CB&I  
12005 Ford Road, Suite 600  
Dallas, Texas 75234  
Tel: 972.773.8400  
Fax: 972.773.8401  
www.CBI.com

Re: Pescadito Environmental Resource Center - Webb County  
Municipal Solid Waste (MSW) Permit Application No. 2374  
Permit Application – Second Notice of Deficiency (NOD)  
Tracking Nos. 14669041(19666994); CN603835489/RN106119639

CB&I Environmental and Infrastructure, Inc. (CB&I) is in receipt of your letter dated October 19, 2015 transmitting a request for additional information regarding the referenced application. Our submittal is formatted as follows:

PROJ NO.	148866	DATE:	APRIL 2015
DESIGNED BY:		DRAWING NO.	III
DRAWN BY:	MTE		<b>B.1-4</b>
CHECKED BY:	RDS		
APPROVED BY:	MWO		4 OF 6 SHEETS

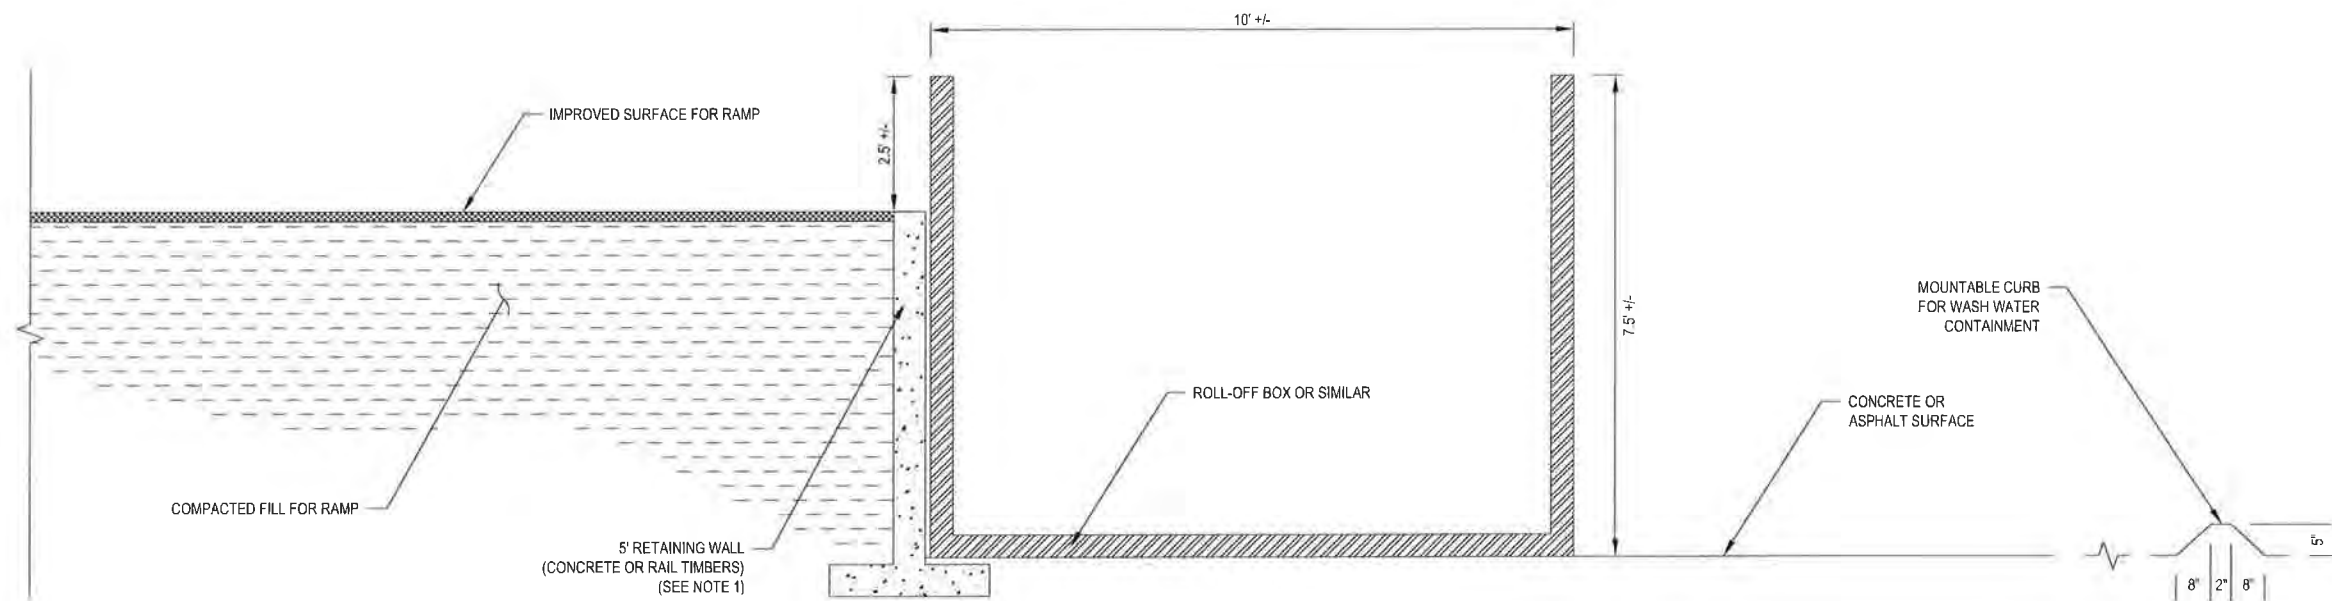
1. Section 3.3 indicates that the citizen's convenience center (CCC) will be constructed of reinforced concrete and/or asphalt. In response to the first NOD, a cross-section drawing was provided (Drawing No. III B.1-4) and it indicates that the CCC's floor will be the existing ground. Please make revisions as necessary and/or explain how the existing ground and the

mountable curbs around the CCC facility will prevent groundwater contamination in accordance with 30 TAC §§330.55(b) and 330.63(b)(4).

***Response: Drawing No. III-B.1-4 has been revised to indicate the use of concrete or asphalt at the CCC. Attached is a revised Title Page, Table of Contents and Drawing No. III-B.1-4.***

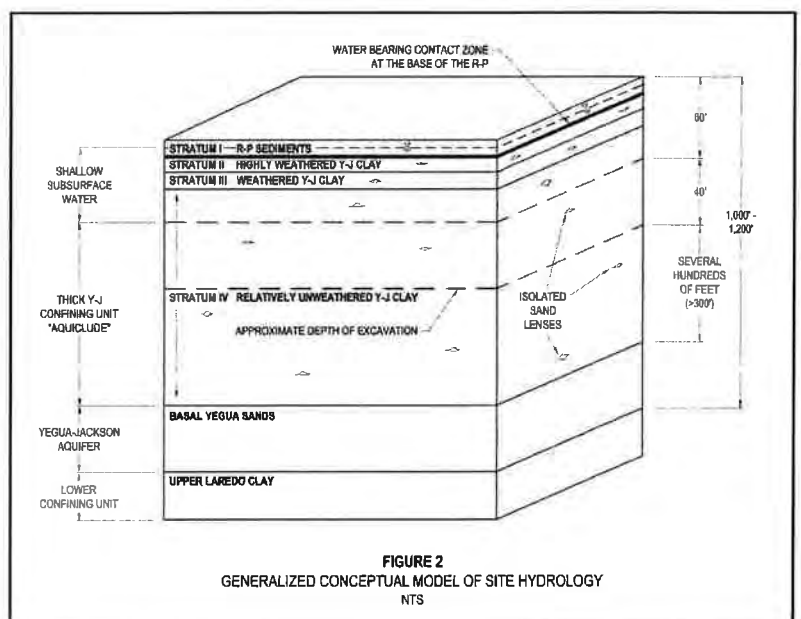
d. Please provide a summary description and a graphical representation of what is considered the site’s regulated uppermost aquifer and all hydraulically connected units. The description and/or representation will include factual or anticipated aquifer extent, thickness and depth, to meet the requirements of 30 TAC §330.63(e)(5)(F) and 30 TAC §330.403(e)(1).

***Response: A summary description and graphical representation of the subsurface soils, including the “uppermost aquifer” has been provided in Part III, Attachment III-E - Geology Report. Attached is a revised Title Page, Table of Contents and text of Attachment III-E - Geology Report.***

The subsurface conditions beneath the site are characterized as follows from the ground surface downward. See Figure 2 for a graphical representation:

GROUNDWATER MONITORING SYSTEM PLAN

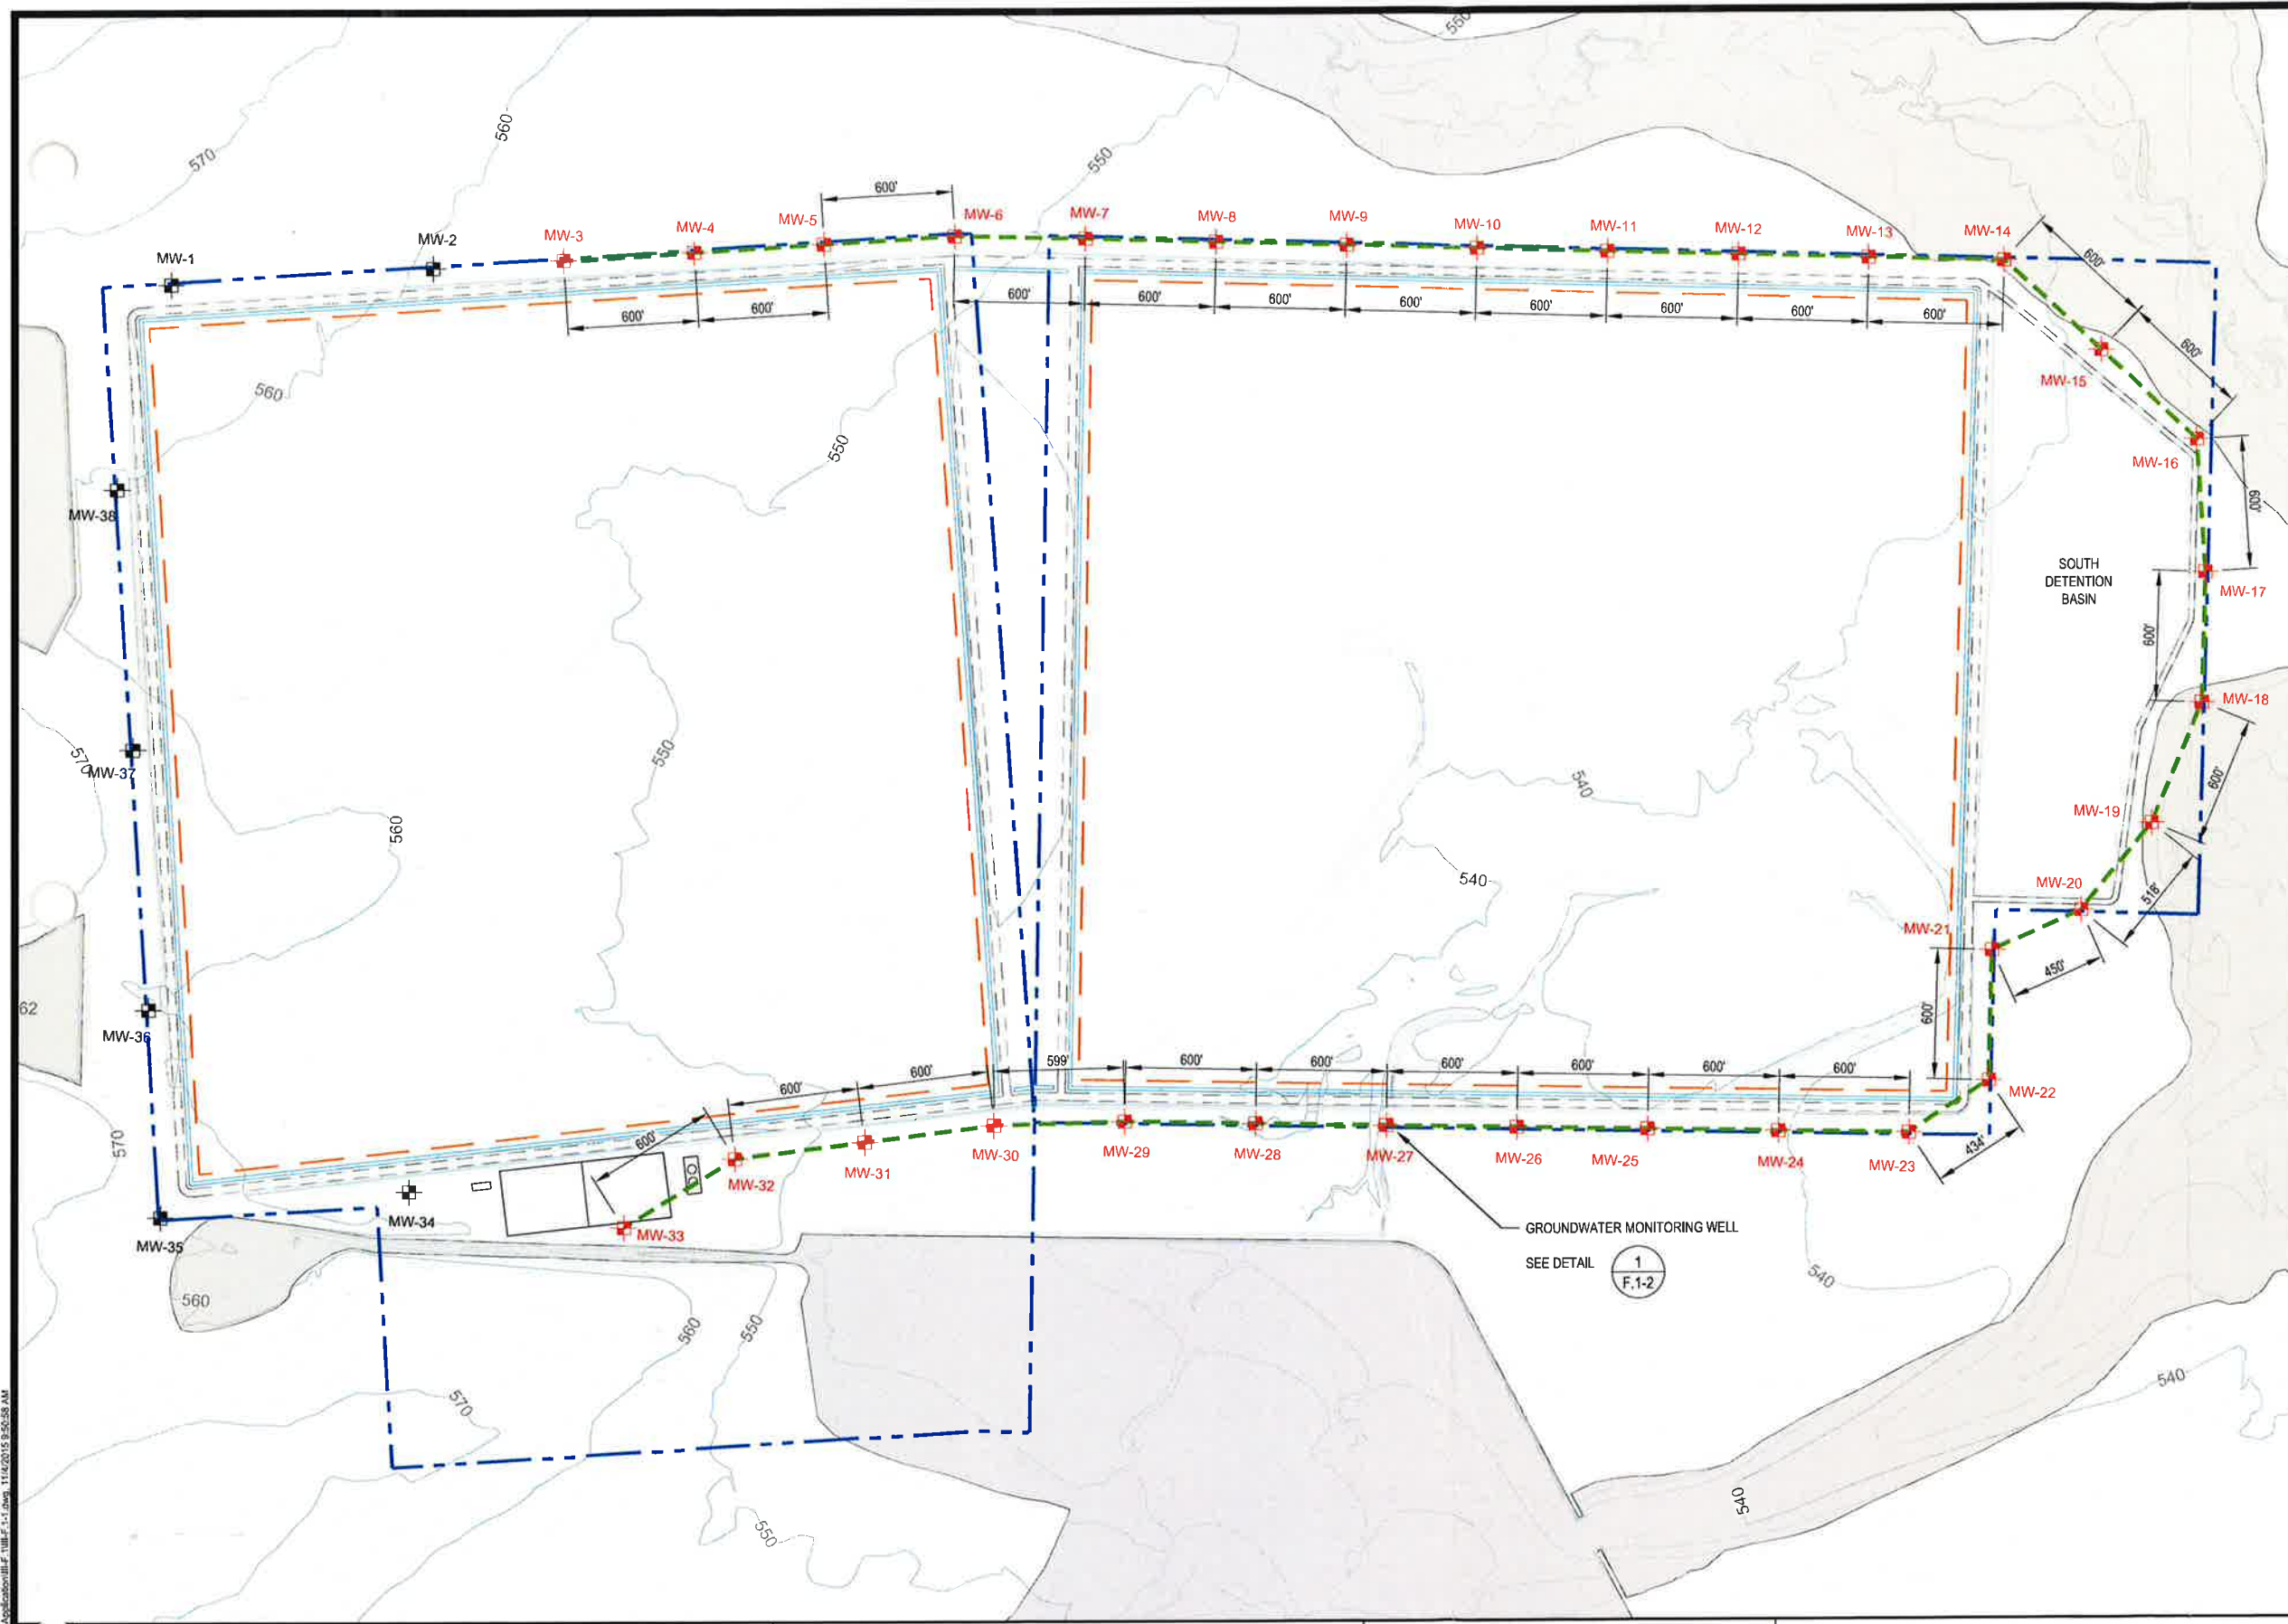
During a meeting with the TCEQ on October 29, it was suggested that Drawing No. III-F.1-1 located in Appendix III-F.1 should be updated to show the spacing between compliance wells and to label the South Detention Basin. These changes have been made and revised Title Page, Table of Contents and Drawings III-F.1-1 and III-F.1-2 are attached.
